SCC\_59761

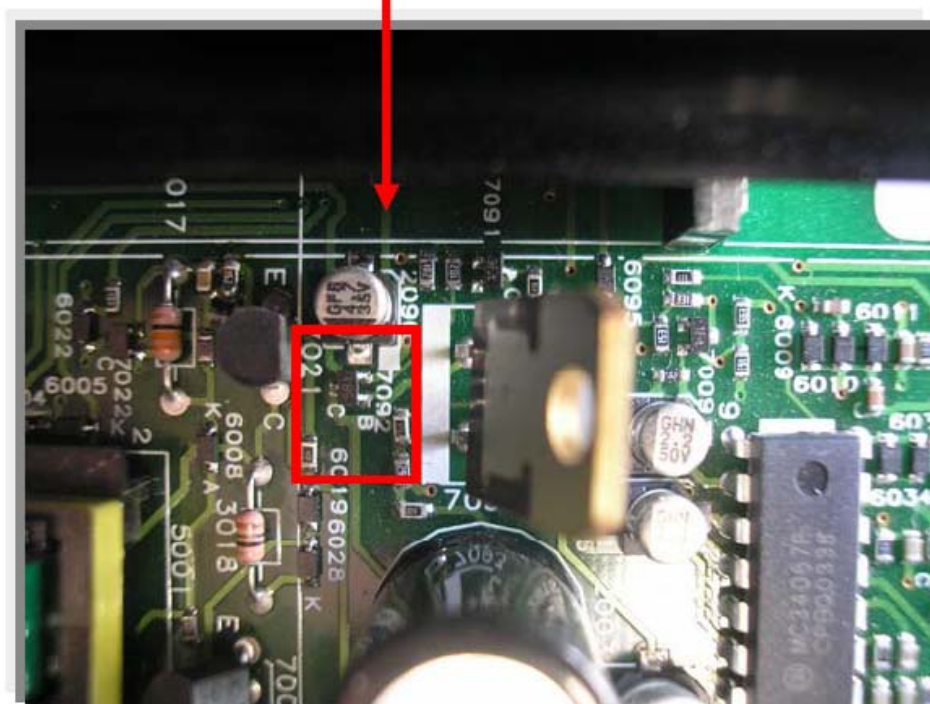
1. REPLACE T7092

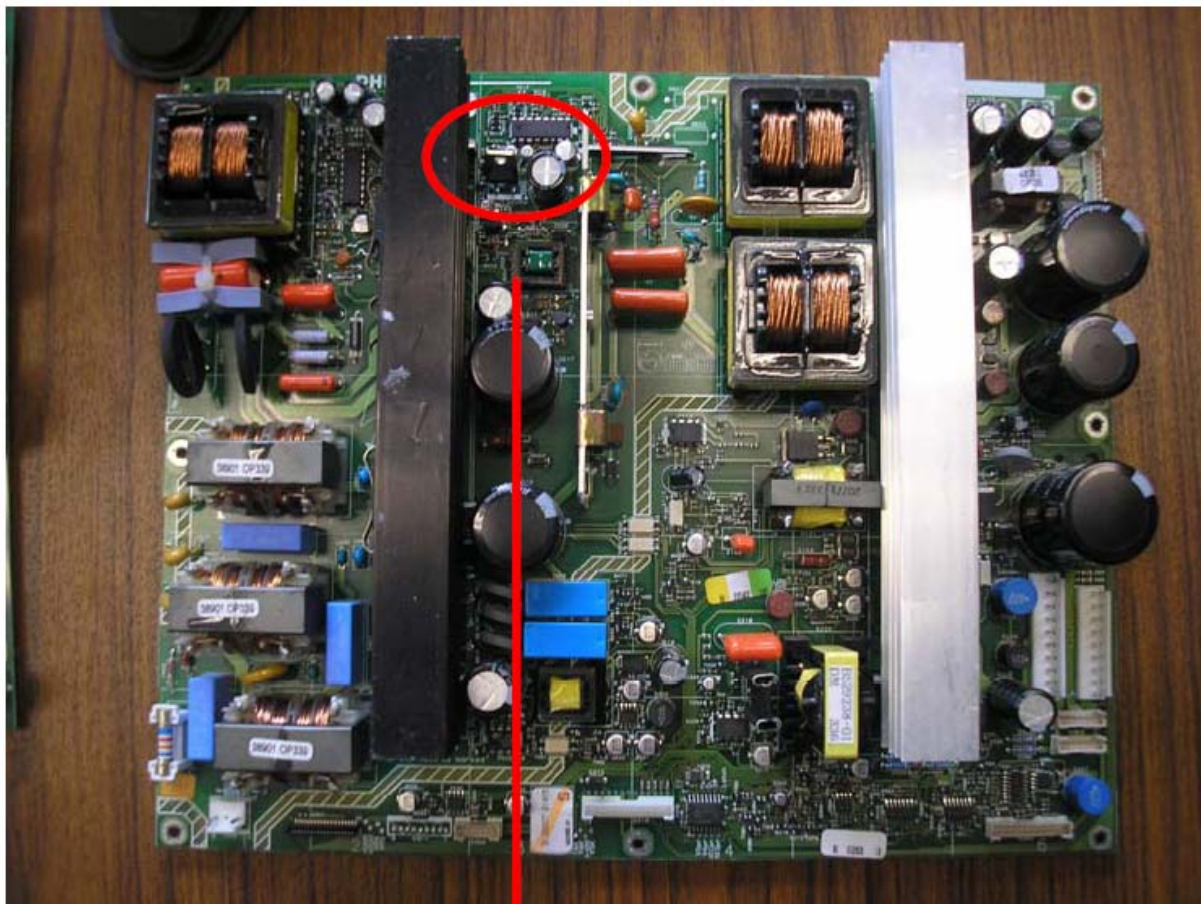
## **2. SCRATCH A TRACK ON BOTTOM OF THE FHP SUPPLY**

Cut the track  
near to  
component C2505

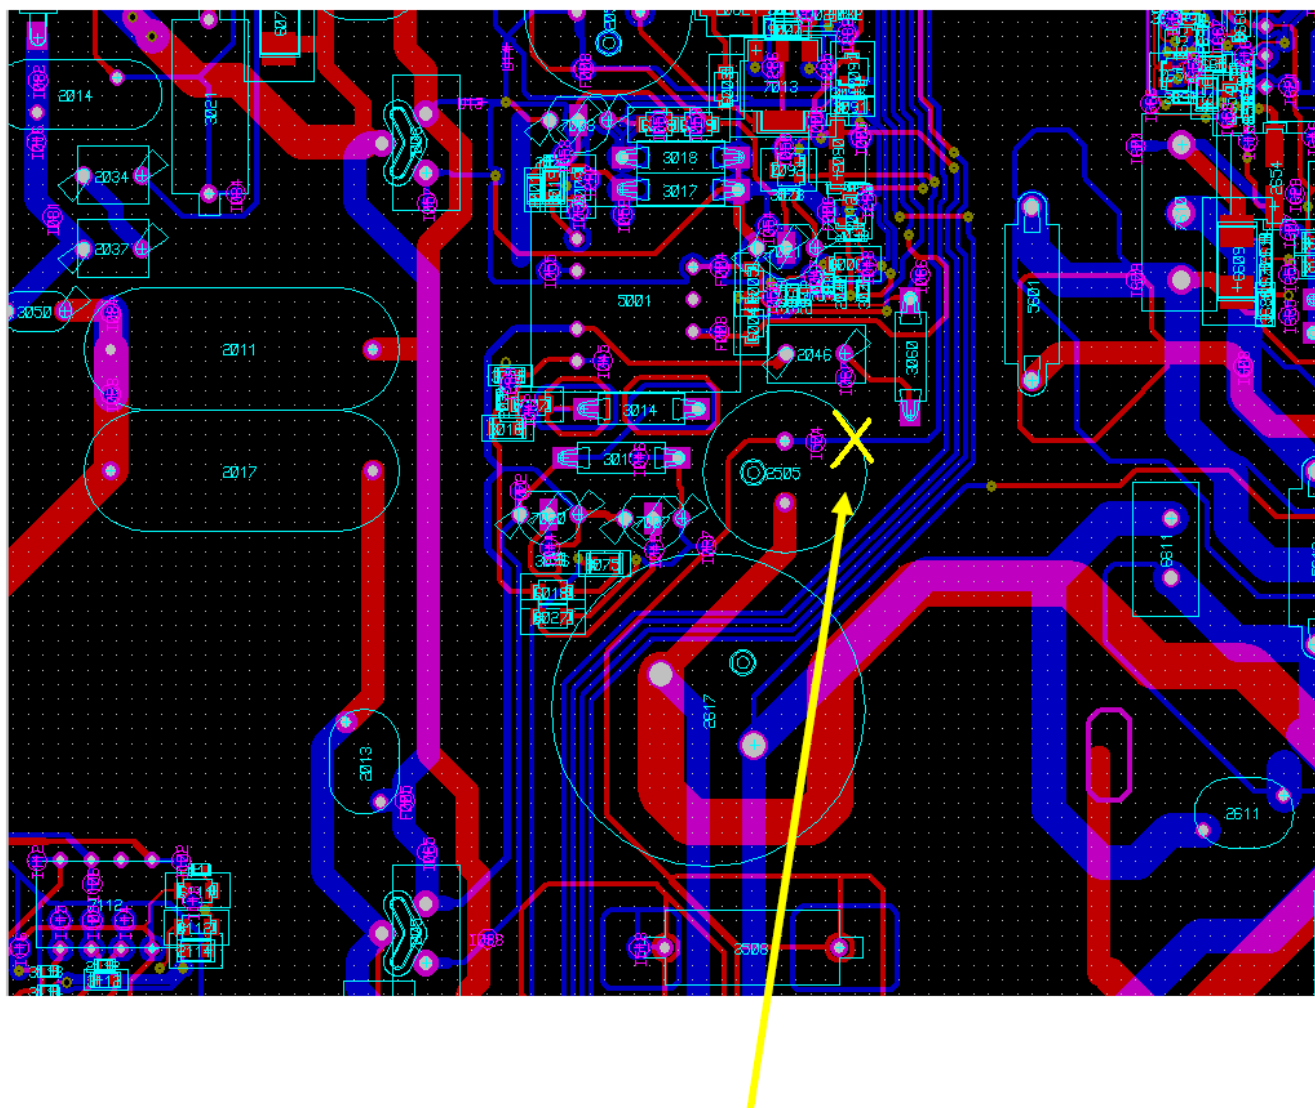
**3. ADD 10R WITH WIRE ON TOP OF THE FHP SUPPLY**
